# Teviot Wind Farm

## Turbine Modifications

**Figure 3: Comparison between Scoping Layout and Current Site Layout**

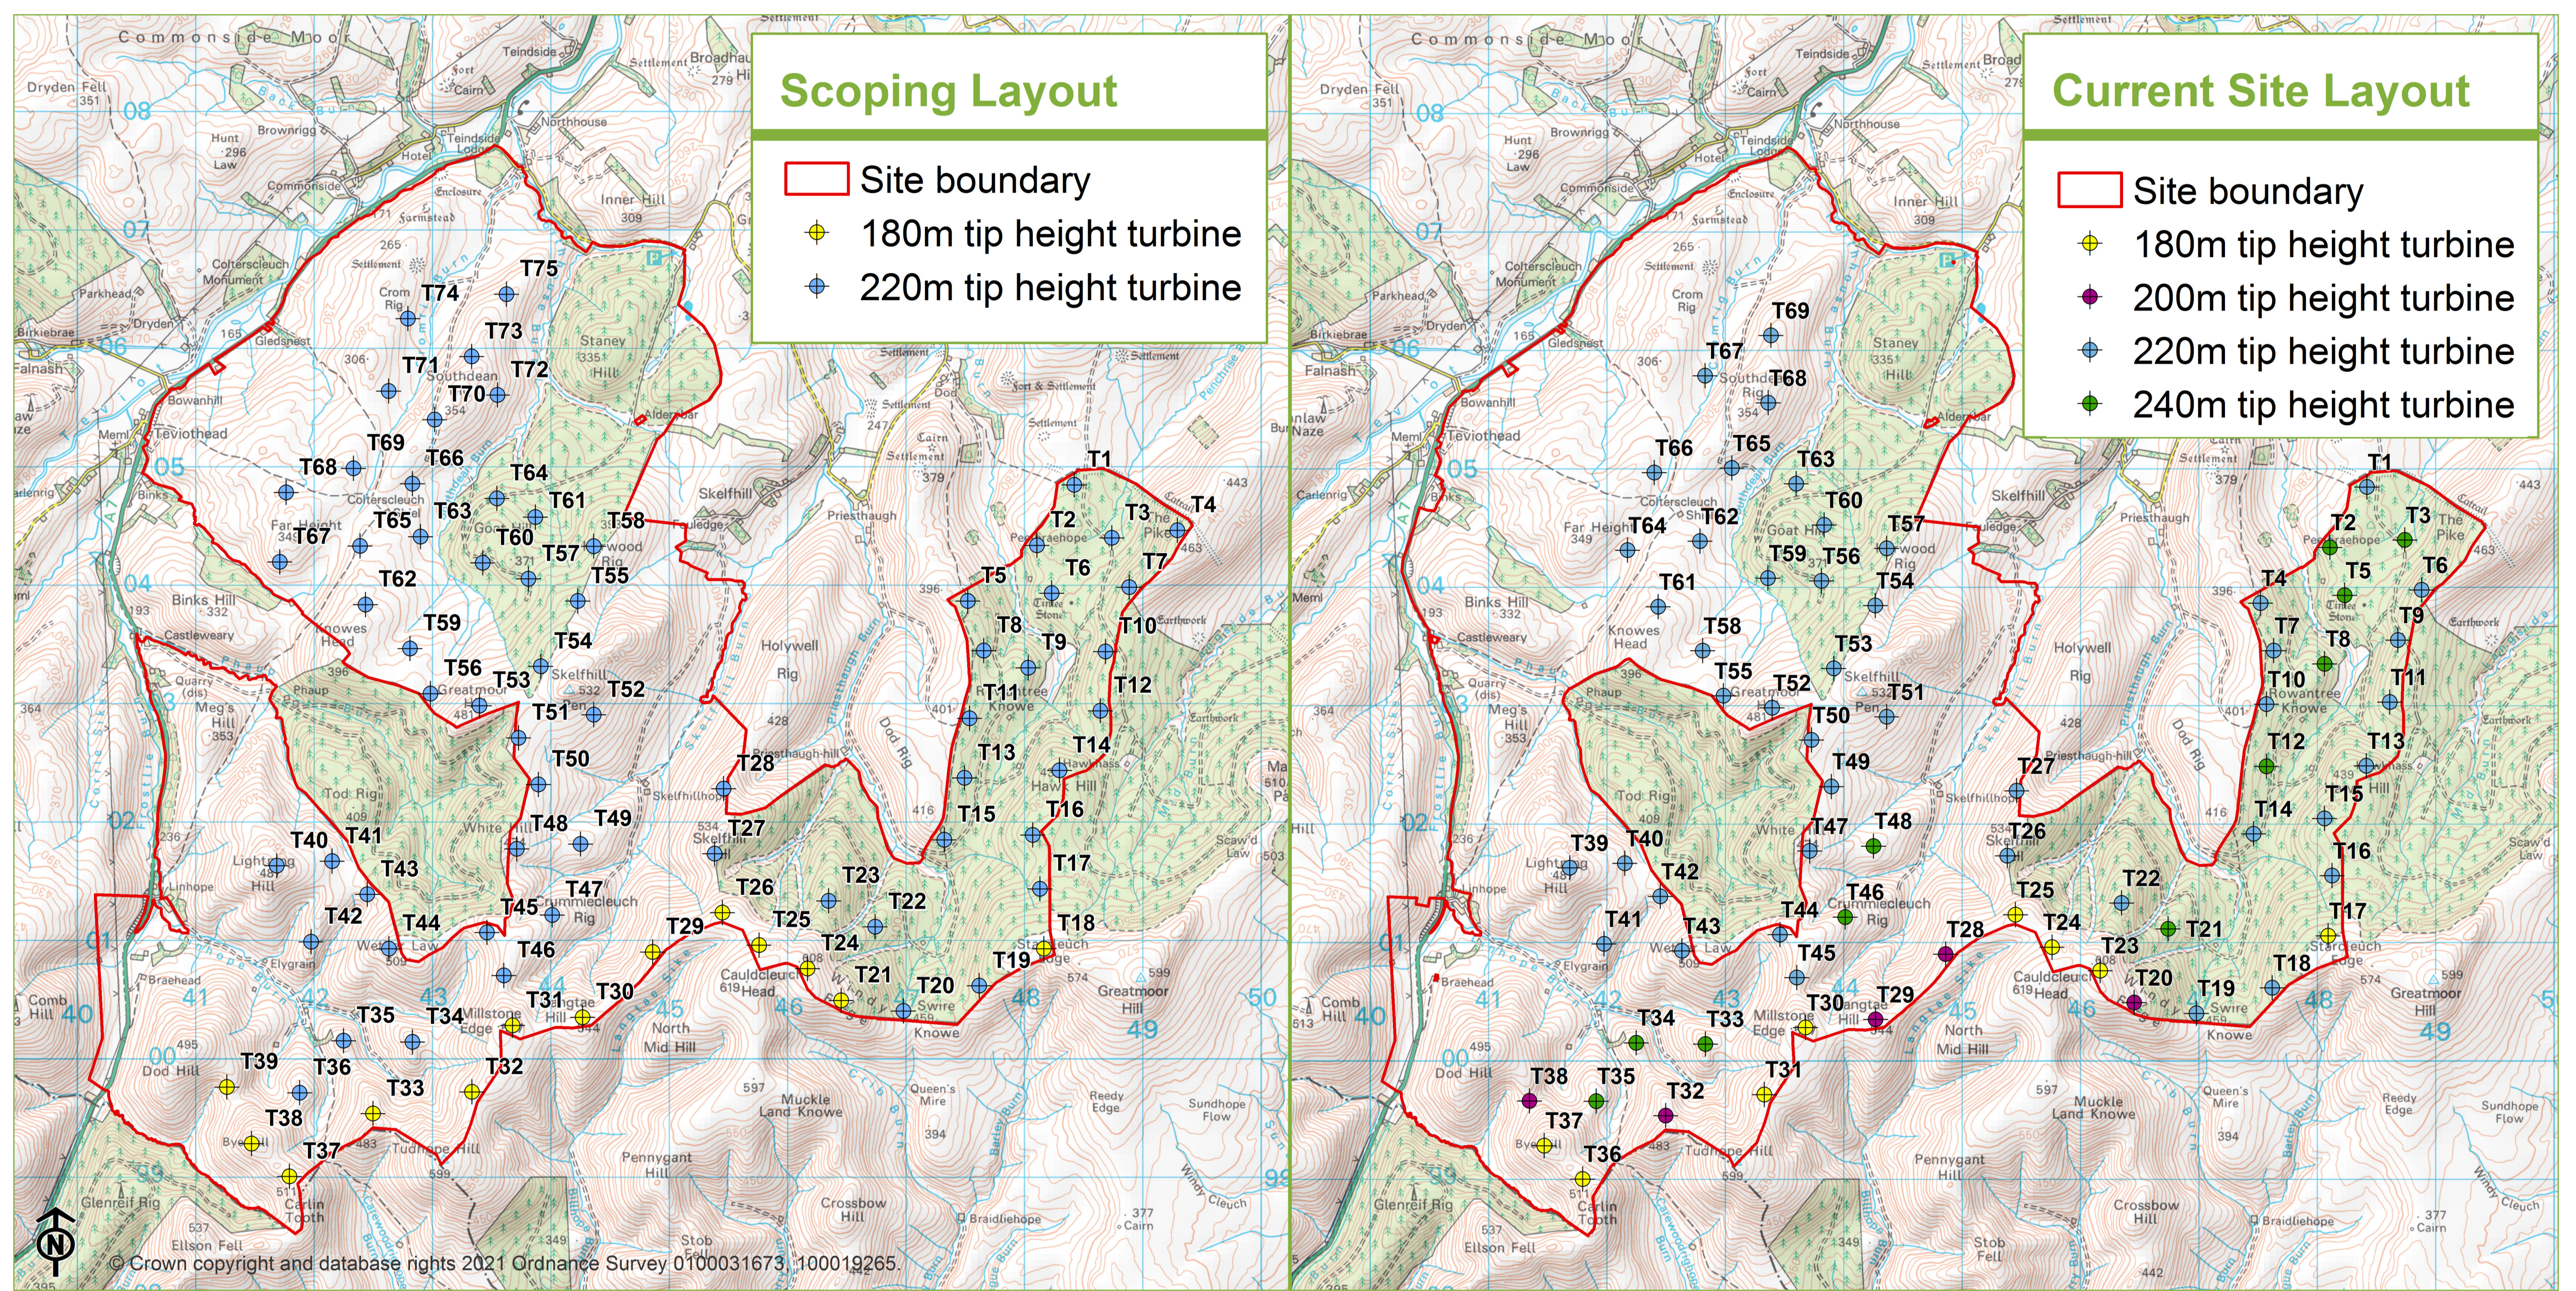
Following the submission of the EIA Scoping request in March 2021 (see **Board 14**), there have been a number of amendments made to the layout to respond to key landscape and visual sensitivities and design objectives, notably the removal of six turbines as shown in **Figure 3**, resulting in a reduction from 75 turbines to 69 turbines. This has reduced visibility of the project in views from around Teviothead (removal of Scoping Layout Turbines T67, T68, T70, T73 and T75), and consolidates the views of the proposed wind farm from the north (removal of T4). Some turbine tip heights have increased to provide uniformity in height above ground level across the site and would increase the project's energy yield.

**Figure 4: Comparative Wireline Showing Scoping Layout and Current Layout in views from around Teviothead (Viewpoint 1).**

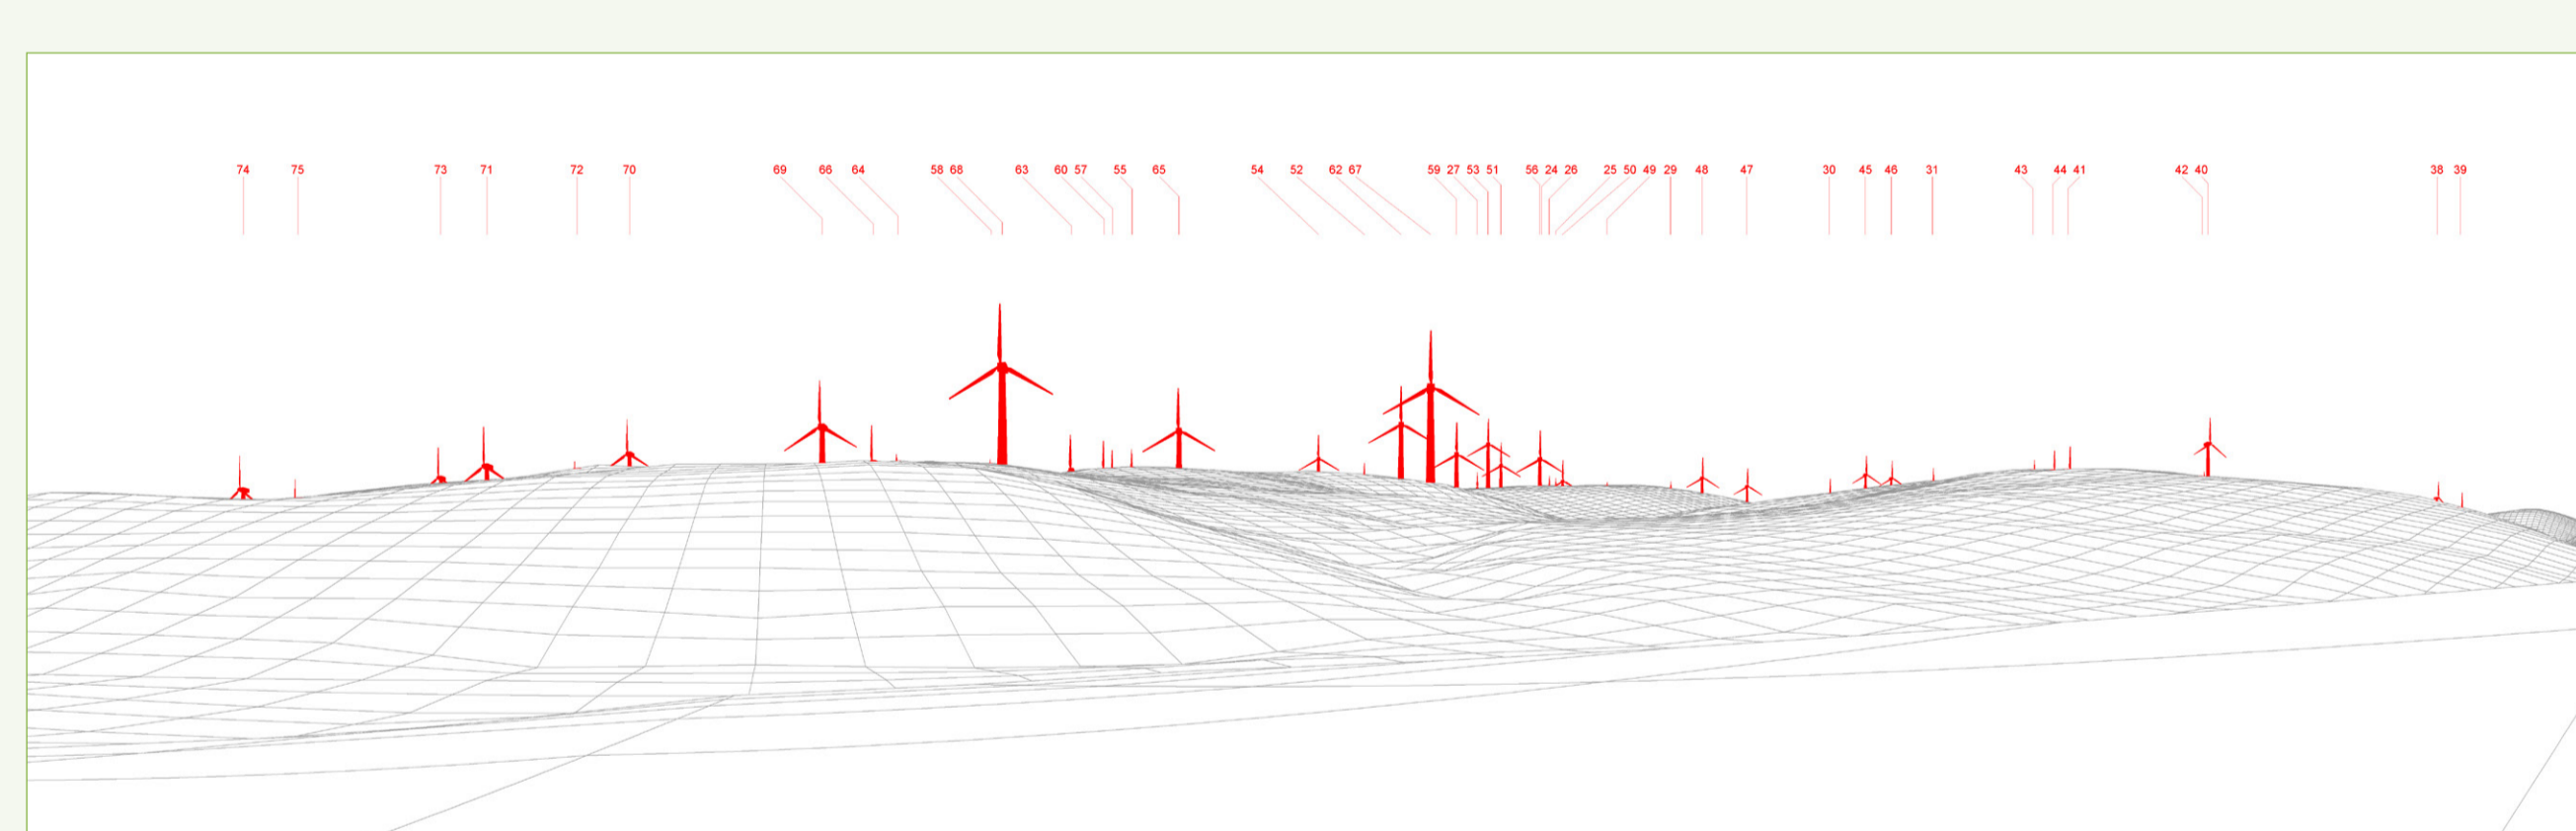
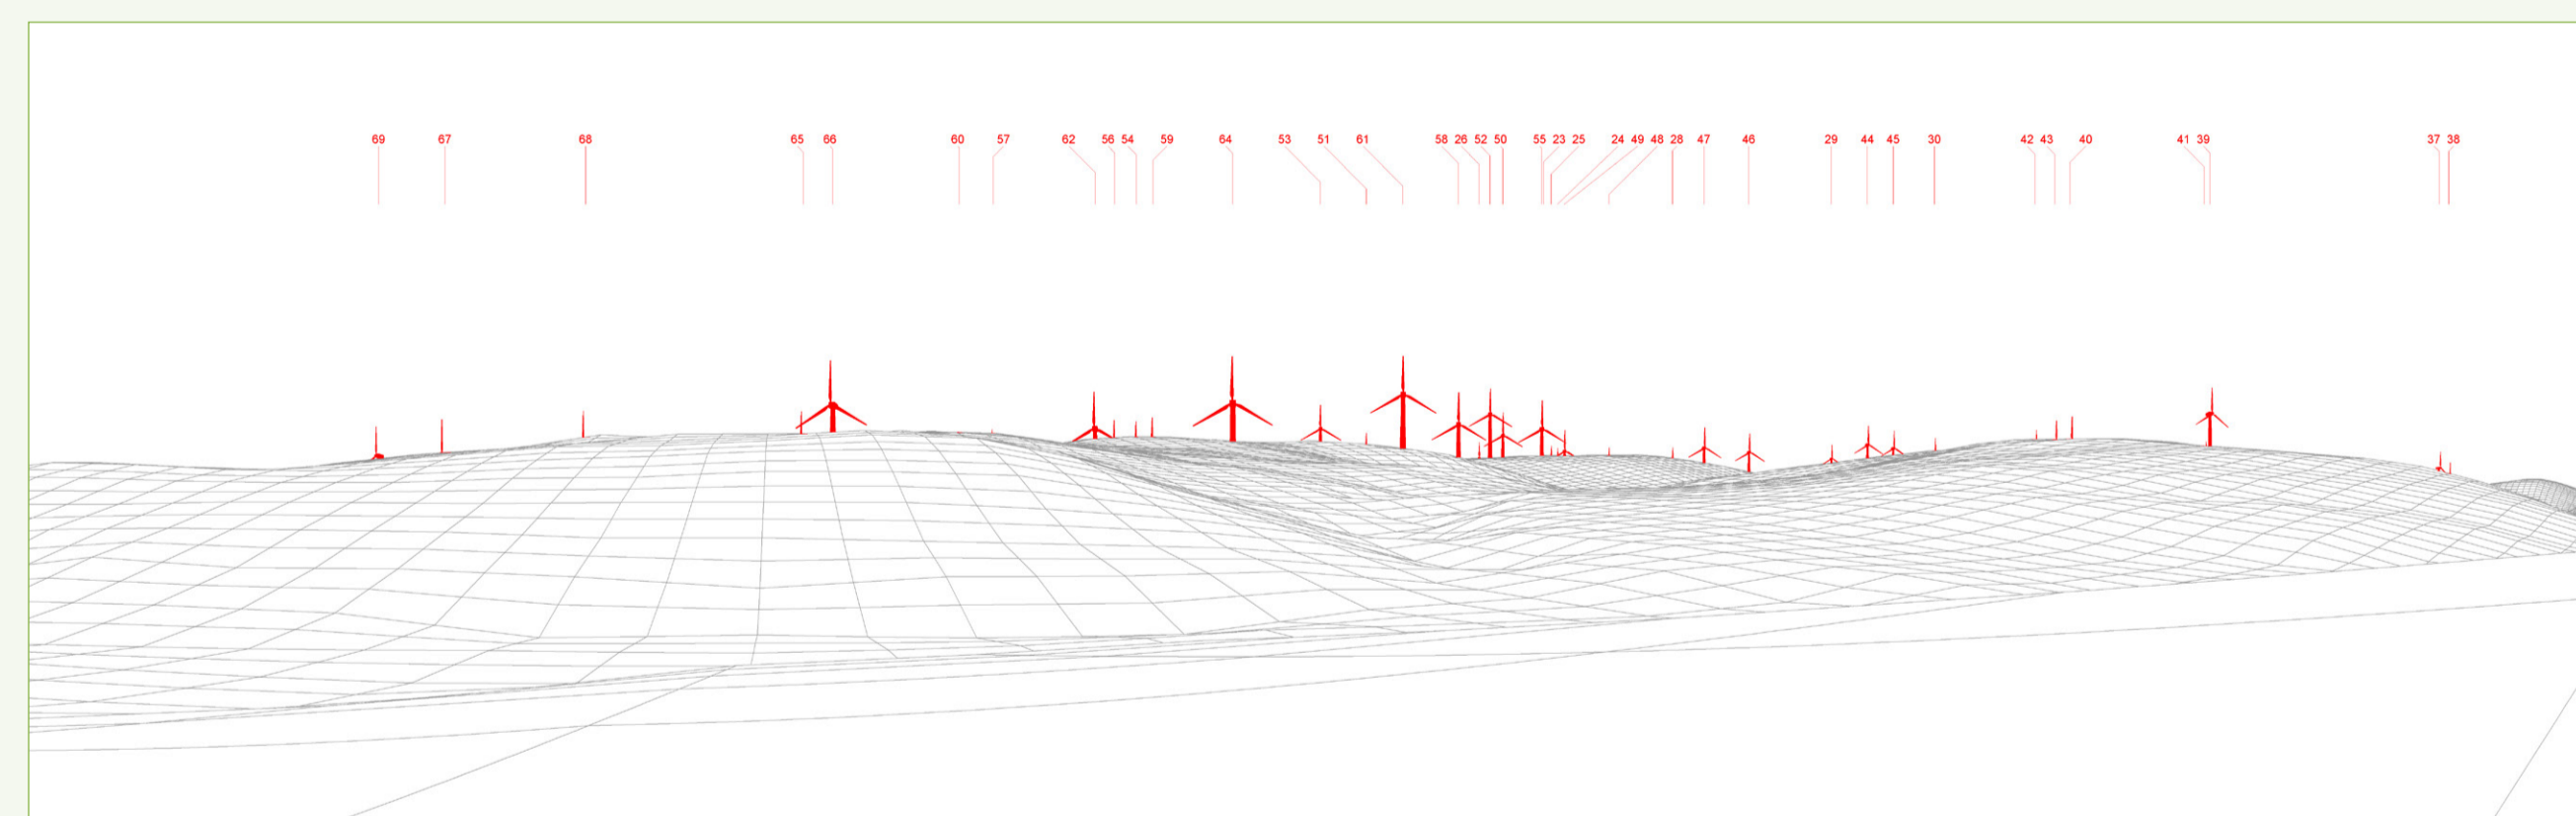
The comparative wirelines shown in **Figures 4** and **5** below illustrate the positive benefits that removing the six turbines has had on views from around Teviothead and to the north of Hawick from the A7.
